ERRATA # 0183 20190304 DSC MMSI

**NMEA 0183 ver. 4.00, 4.10, and 4.11
DSC – Digital Selective Calling Information**

DSC – Digital Selective Calling Information

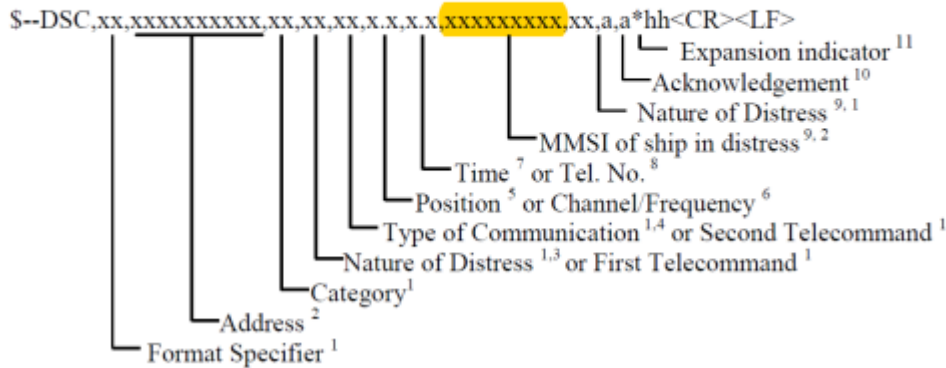
In the DSC- Digital Selective Calling Information Sentence there is a Typo in the MMSI of Ship Distress Field. The field MMSI of Ship in Distress Field shows to be a nine digit number xxxxxxxxx (nine “x”) See highlight below. This is **incorrect**. The DSC MMSI field should be a fixed length field consisting of ten numerical digits. For more information refer to Rec. ITU-R M.585-7 for MMSI formatting for DSC and other systems.

The MMSI of ship in distress field should contain xxxxxxxxxxxx (ten “x”).

This will be corrected in the next publication of NMEA 0183.
